# UNITED STATES PATENT AND TRADEMARK OFFICE

APPLICATION NO.	FILING DATE	FIRST NAMED INVENTOR	ATTORNEY DOCKET NO.	CONFIRMATION NO.
09/768,271	01/25/2001	Tsukasa Yajima	PNET.009D	3802

<b>Office Action Summary</b>	<b>Application No.</b> 09/768,271	<b>Applicant(s)</b> YAJIMA, TSUKASA	
	<b>Examiner</b> Anh D. Mai	<b>Art Unit</b> 2814

## **DETAILED ACTION**

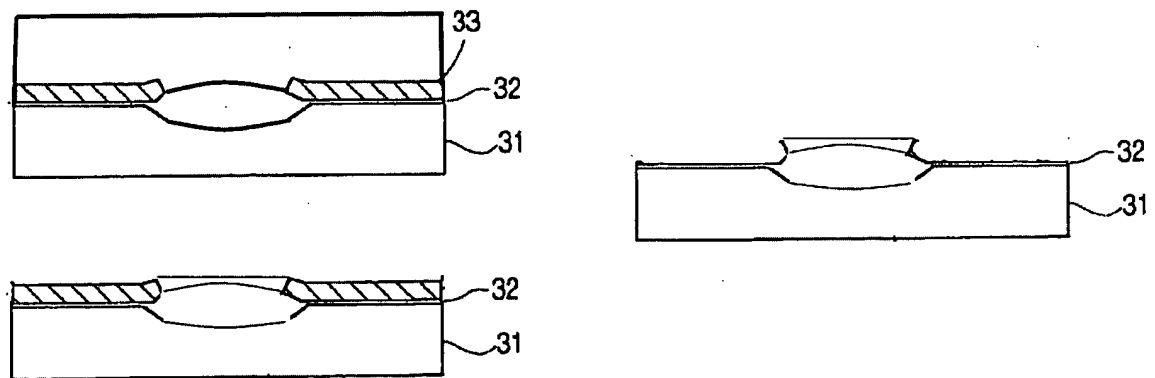
The convex nature of the field oxide are well known in the art and has been recognized by the Applicant. As illustrated above, after the planarization, the middle portion of the protective layer should be thinner than the rest of the protective layer on the field oxide, regardless of the protective has been formed at the edge or not.

Planarizing the polysilicon layer 11 on the field oxide 34 only flattens the surface, not forming an uniform thickness.

The above assertion clearly shows that the Applicant could not distinguish between "uniform thickness" and "planar surface". Since planarize the top surface only results in flattening the top surface. In the instant case, as shown in the illustration above, planarizing the top surface of the polysilicon layer on a field oxide (LOCOS) only results in flattening surface, not uniform thickness.
